CITY OF COCONUT CREEK

DEVELOPMENT REVIEW COMMITTEE (DRC) REVIEW #1

PROJECT NAME:		Lyons Community Center Site	
PROJECT NUMBER:		18030005	
LOCATION:			
APPLICANT/AGENT:		Debra Hernandez, RLA, IBI Group	
REVIEW/APPLICATION		Site	
DISCIPLINE	REVIEWER	EMAIL	TELEPHONE
DRC Chair	Liz Aguiar – Principal Planner	laguiar@coconutcreek.net	(954) 973-6756
Planning	Linda Whitman – Senior Planner	lwhitman@coconutcreek.net	(954) 973-6756
Planning	Natacha Josiah – Planner	NJosiah@coconutcreek.net	(954) 973-6756
Building	Sean Flanagan - Chief Structural Inspector	sflanagan@coconutcreek.net	(954) 973-6750
Engineering	Eileen Cabrera - Engineer II	ecabrera@coconutcreek.net	(954) 973-6786
Fire	Jeff Gary – Fire Marshal	jgary@coconutcreek.net	(954) 973-1563
Landscape	Scott Peavler - Landscape (consultant)	speavler@craventhompson.com	(954) 739-6400
Police	Brandi Delvecchio - Police Department	bdelvecchio@coconutcreek.net	(954) 956-6721

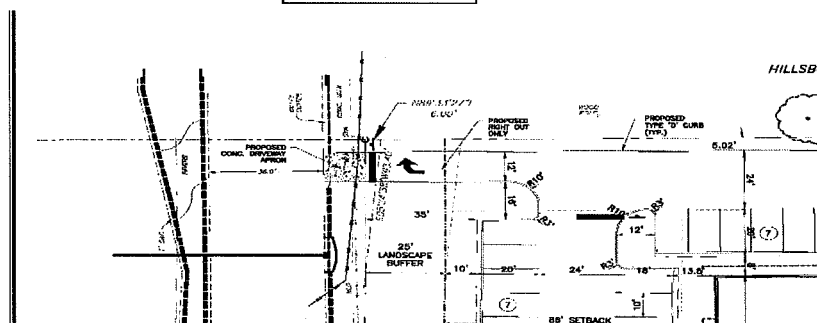
7. Provide 25 LF double yellow pavement markings for all stop signs/ stop bar locations.

Response: As shown on Sheet 6.0, the south entry/exit driveway connection provides a note to install 25 lf double yellow, stop sign and stop bar. The northwest driveway connection is an exit-only drive and provides for a stop sign, stop bar, right-turn only and do not enter sign.
